Product/Process Change Notice (PCN)	
<input checked="" type="checkbox"/> Major Change <input type="checkbox"/> Minor Change	
PCN Number: PCN_UtRJ45LAN_20250213 Affected Series: WE-RJ45LAN Affected Part Number: 7497011611A PCN Date: 2024-11-13 (YYYY-MM-DD) Effective Date: 2025-02-13 (YYYY-MM-DD)	Change Category: <input type="checkbox"/> Equipment/Location <input checked="" type="checkbox"/> General Data <input checked="" type="checkbox"/> Material <input checked="" type="checkbox"/> Process <input checked="" type="checkbox"/> Product Design <input type="checkbox"/> Shipping/Packaging <input type="checkbox"/> Supplier <input type="checkbox"/> Software
Contact: Product Management Phone: +49 (0) 7942 - 945 5001 Fax: +49 (0) 7942 - 945 5179 E-Mail: pcn.eisos@we-online.com	Datasheet Change: <input checked="" type="checkbox"/> Yes <input type="checkbox"/> No Attachment: <input type="checkbox"/> Yes <input checked="" type="checkbox"/> No

DESCRIPTION OF CHANGE: <p>In order to enhance the product reliability, Würth Elektronik eiSos will implement a new spot welding design technology.</p> <p>Along with this, further general improvements are done in design and process like shield connection a

Use automatic spot welding and standardize core diameters and inner structure:

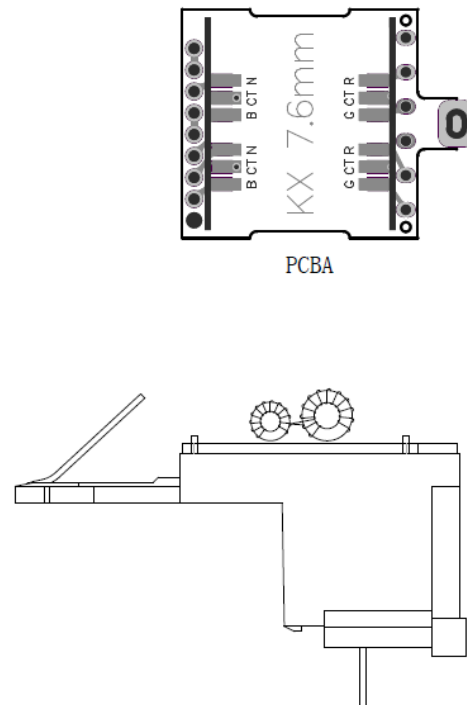
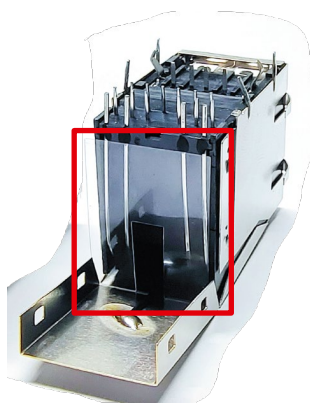
Assembly of discrete module with cores inside

Automatic assembly process by spot welding

Backside view open with insulation film:

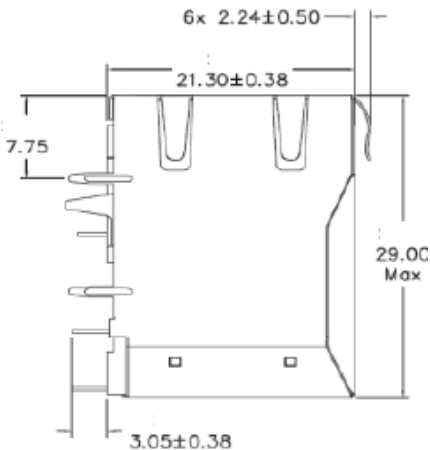
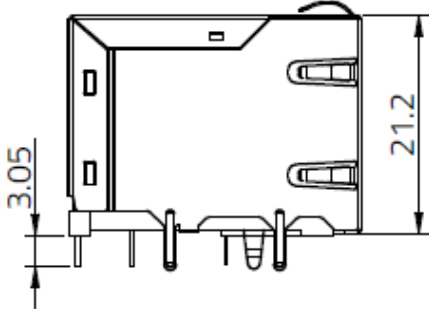
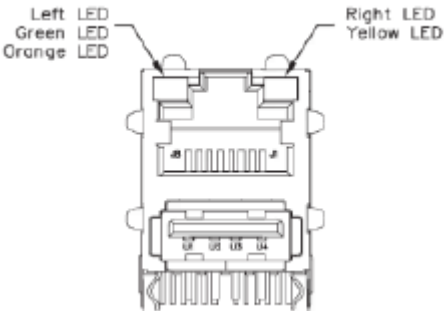
Transparent insulation film out of the material PET

Black insulation film out of the material PC

7497011611A:

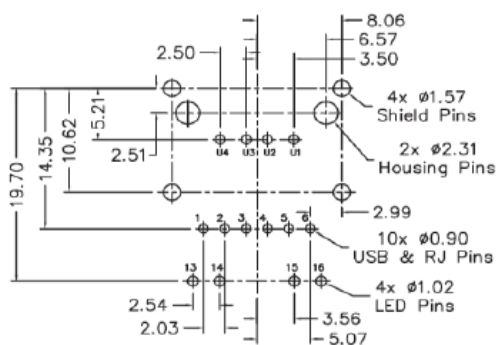
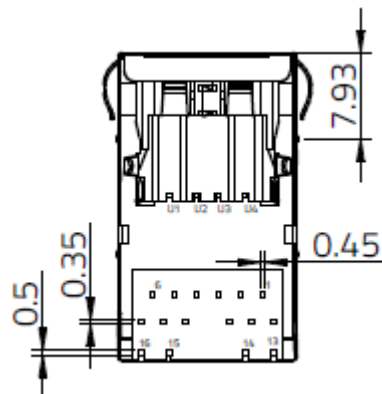
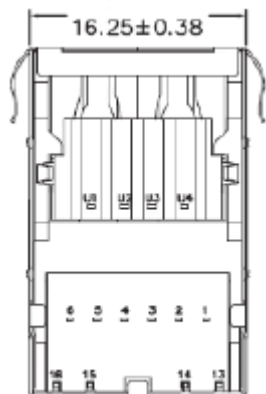
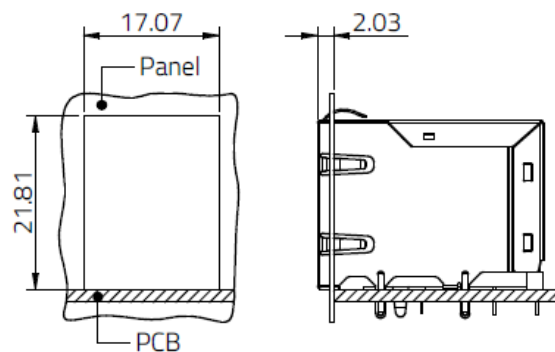
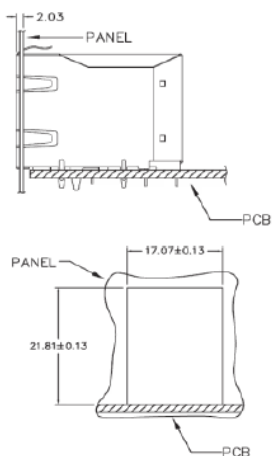
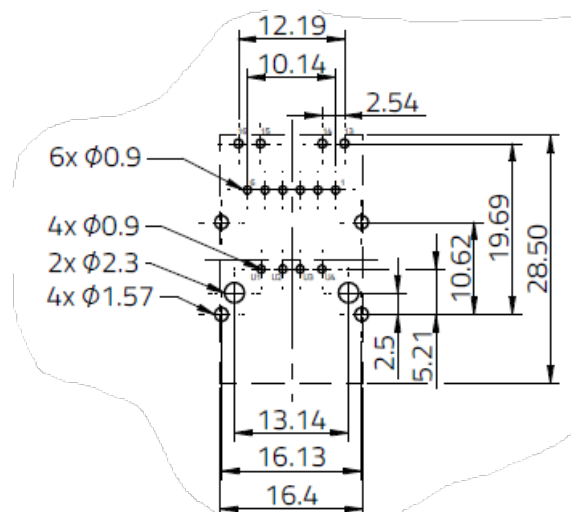
2.) Datasheet corrections and details for the part number:

Recommended PCB layout (Component Side View)
 All dimension tolerance are ± 0.08 unless otherwise specified

RL: 1 – 30 MHz 30 – 45 MHz 45 – 60 MHz 60 – 80 MHz	RL: 1 – 30 MHz 30 – 60 MHz 60 – 80 MHz 80 – 100 MHz
CCMR: 1 – 100 MHz	CMRR: 1 – 30 MHz 30 – 60 MHz 60 – 100 MHz
CT: 1 – 100 MHz	CT: 1 – 60 MHz 60 – 100 MHz
HIPOT: 1500 V(rms) for 1 min.	HIPOT: 2250 V(DC) for 1 min.
